SALEM NUCLEAR GENERATING STATION, UNIT NO. 1

Amendment No. 31
License No. DPR-70

ATTACHMENT TO LICENSE AMENDMENT NO. 31

SAFETY EVALUATION BY THE OFFICE OF NUCLEAR REACTOR REGULATION
RELATED TO AMENDMENT NO. 31 TO FACILITY OPERATING LICENSE NO. DPR-70

FIGURE 6.2.2 FACILITY ORGANIZATION - SALEM GENERATING STATION

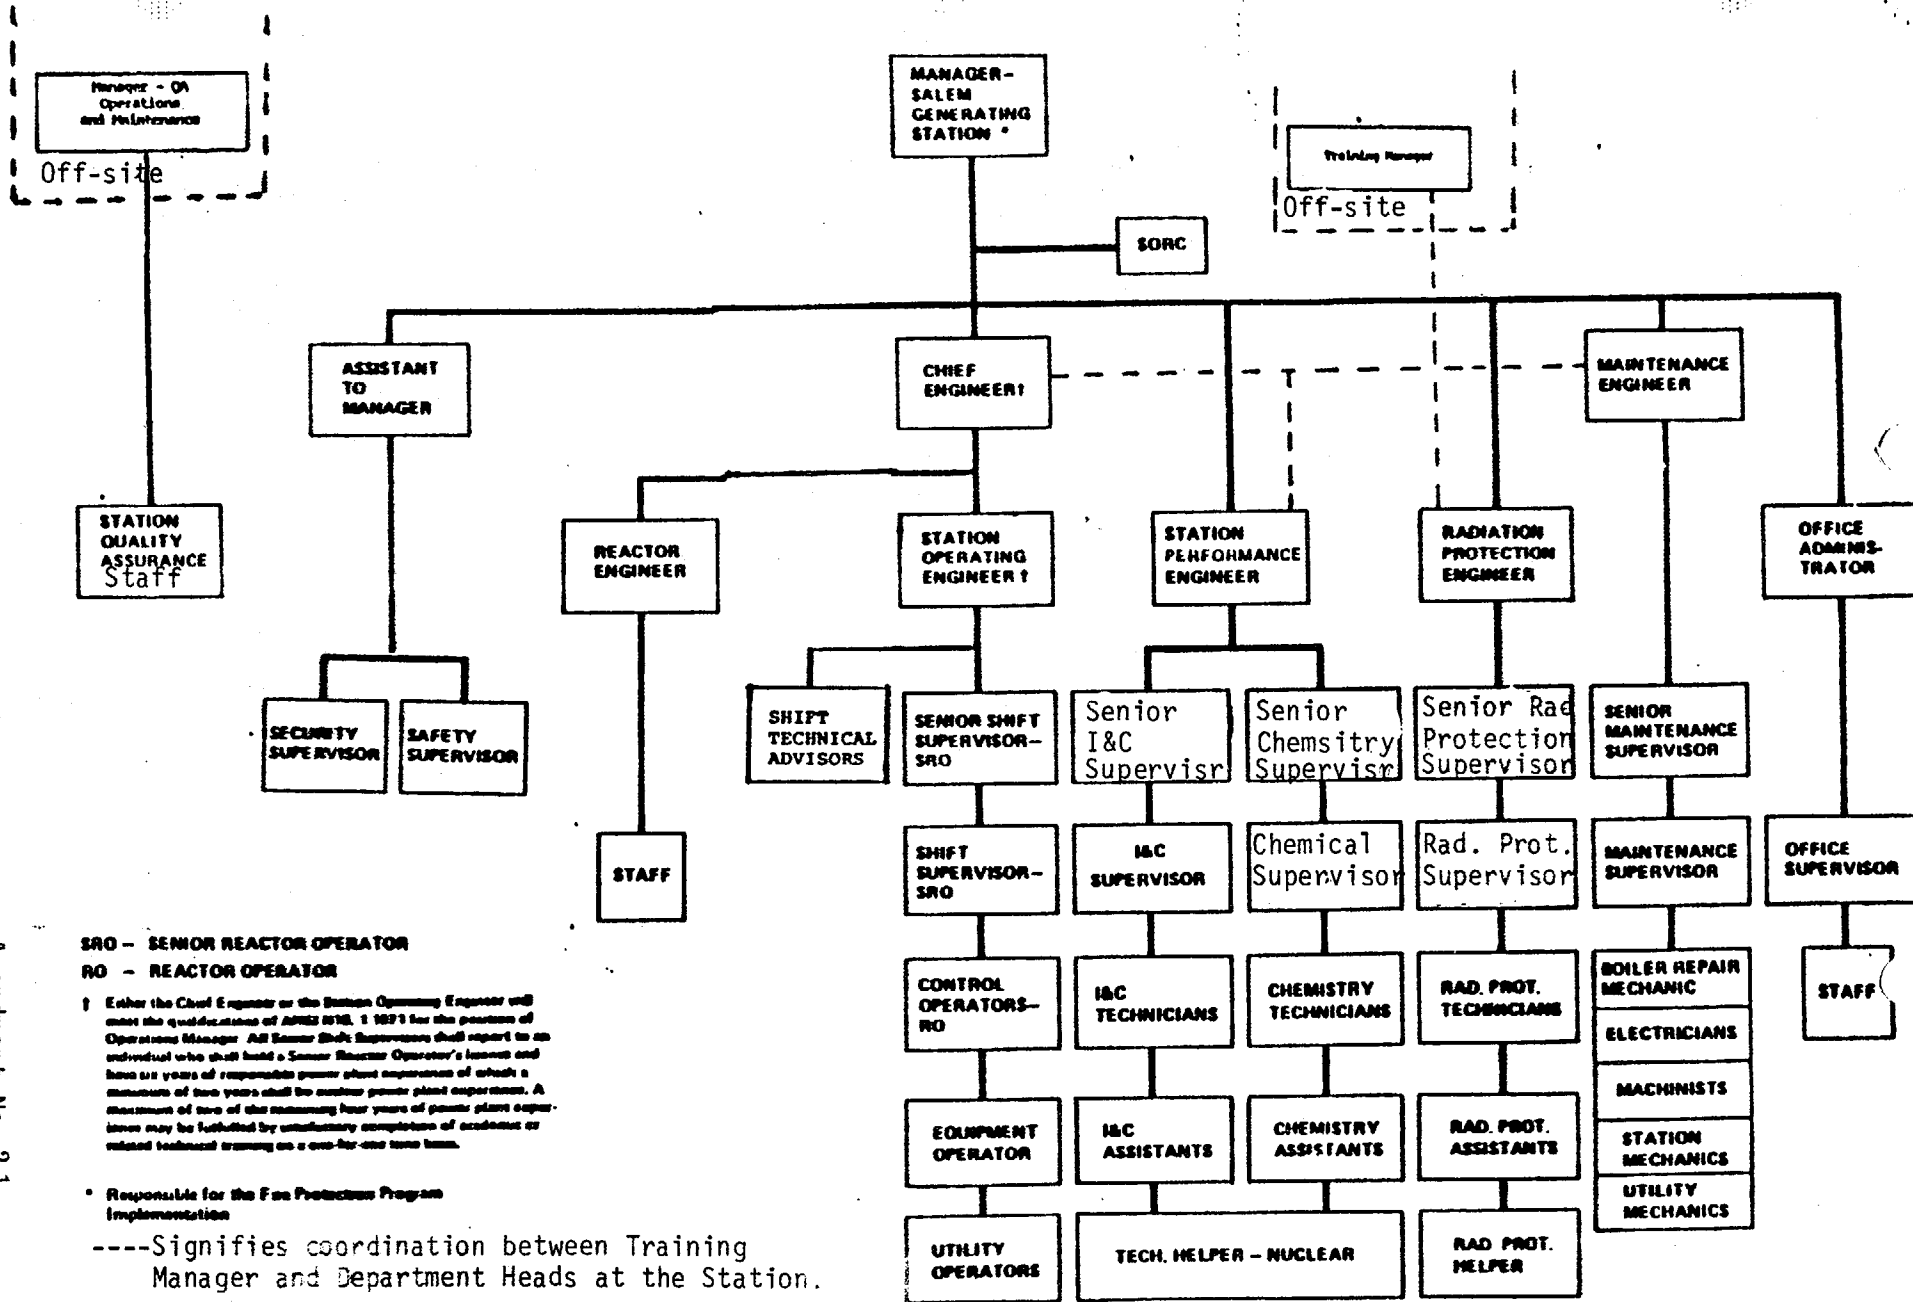
Figure 6.2-2, attached, depicts the proposed new station organization. There are a number of significant changes that the licensee proposes to make. In addition to a number of title changes, the Radiation Protection Engineer has now been moved such that he is free from plant operational pressures and has direct access to the Station Manager. This is in accord with the desires of the NRR Radiation Assessment Branch and is acceptable. The Senior Training Supervisor at the Station has been replaced by a corporate level Training Manager, who coordinates training activities directly with the Department Heads at the Station. This should result in increased emphasis on training and is acceptable.

At the time the license for Unit 2 was issued, the licensee had the Shift Technical Advisors reporting to the Reactor Engineer. By letter dated October 29, 1980, the licensee informed us that, in order to obtain a greater involvement of the STAs in shift operation and an improved awareness of plant conditions, the STAs had been shifted so that they would report to the Operating Engineer rather than the Reactor Engineer. This change is reflected on the attached Figure 6.2-2. This reporting arrangement maintains STA independence from the actual shift operating crew and is acceptable.

Figure 6.2-2 also shows the Station Quality Assurance Staff now reporting to the Manager - QA Operations and Maintenance at the Corporate level who, in turn, reports to the new General Manager - Corporate Quality Assurance, as shown on Figure 6.2-1. This maintains the independence of Station QA activities from operating pressures and is acceptable.

6.2.2 The Facility organization shall be as shown on Figure 6.2-2 and:

FIGURE 6.2-1 OFFSITE ORGANIZATION FOR FACILITY MANAGEMENT AND TECHNICAL SUPPORT

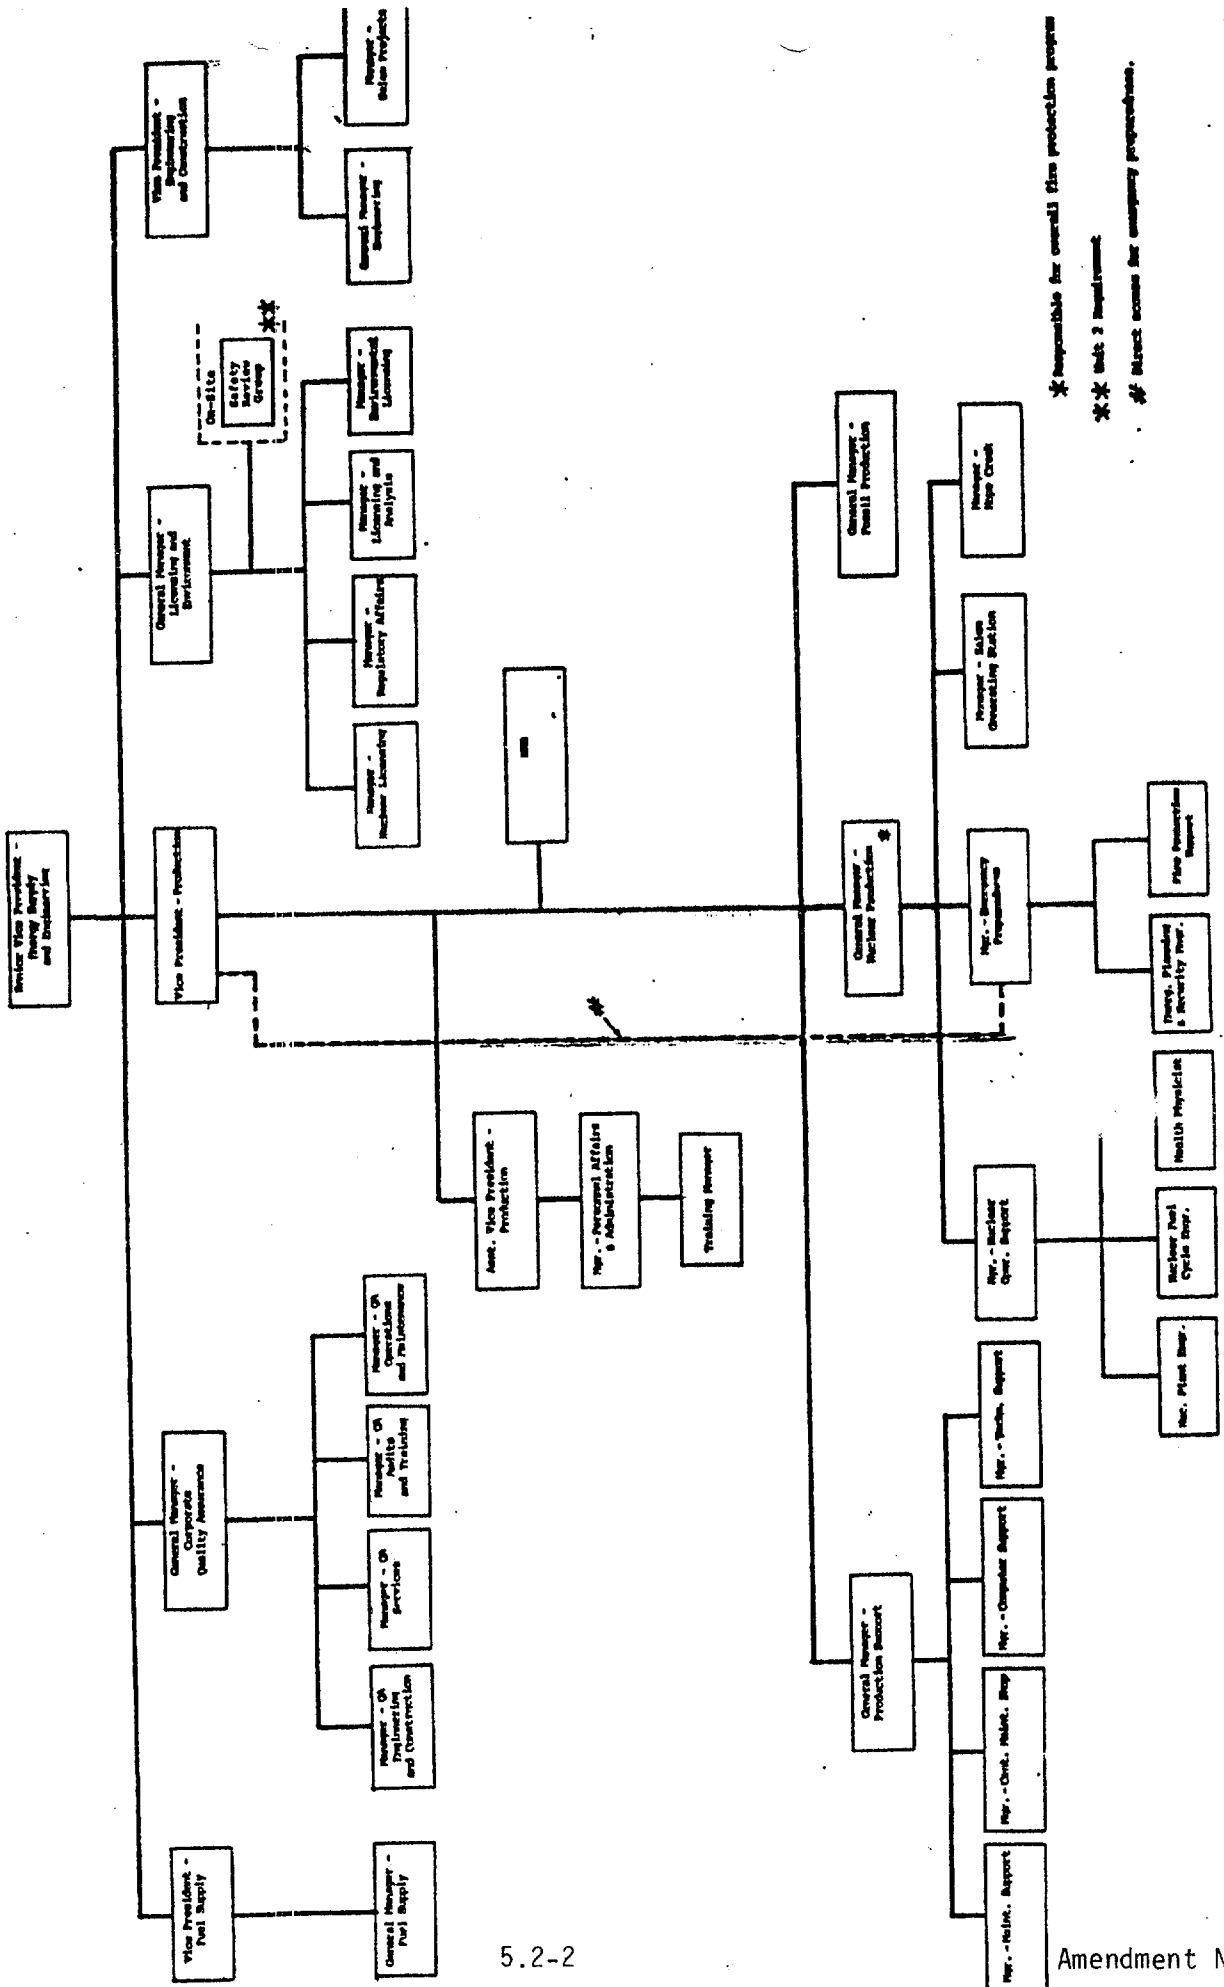
The licensee now proposes to divide the duties previously exercised by the General Manager - Electric Production, by establishing a General Manager - Nuclear Production, a General Manager - Fossil Production, and a General Manager - Production Support. The Company's nuclear plants will now report to the General Manager - Nuclear Production who will also direct the activities of a newly designated Manager - Emergency Preparedness and a Manager - Nuclear Operations Support, previously designated

the Manager - Nuclear Operations. The new General Manager - Production Support will control most of the corporate level technical resources supporting the Company's operating plants. This proposed new organizational arrangement is shown on the attached Figure 6.2-1.

Our evaluation indicates that this proposed new organizational arrangement is superior to the previous arrangement since the new General Manager - Nuclear Production can devote his entire attention to the nuclear plant operation. Further, the Vice President - Production can now look to the General Manager - Production Support for most of the technical resources needed to support safe plant operation. Also, the revised organizational structure provides a Manager - Emergency Preparedness who can devote his attention to the emergency planning, security and fire protection functions at the nuclear plants. As shown in the revised Figure 6.2-1, the Manager - Emergency Preparedness will have direct access to the Vice President - Production on emergency preparedness matters.

The proposed revised organization also provides an Assistant Vice President - Production, who supervises the Manager - Personnel Affairs and Administration, and through him the corporate Training Manager. The Assistant Vice President - Production also will serve as the Chairman of the Nuclear Review Board.

Under the organization in being at the time Salem Unit 2 was licensed, the Manager - Quality Assurance reported to the Vice President - Engineering and Construction. In the new proposed organization, a General Manager - Corporate Quality Assurance has been created, on a reporting level comparable to the Vice President - Engineering and Construction and the Vice President - Production. This is shown on the attached Figure 6.2-1. This change assures the continued separation of the quality assurance function from the production function and, in fact, should result in greater corporate attention being given to quality assurance. We conclude that it is acceptable.

6.2.1 The offsite organization for facility management and technical support shall be as shown on Figure 6.2-1.
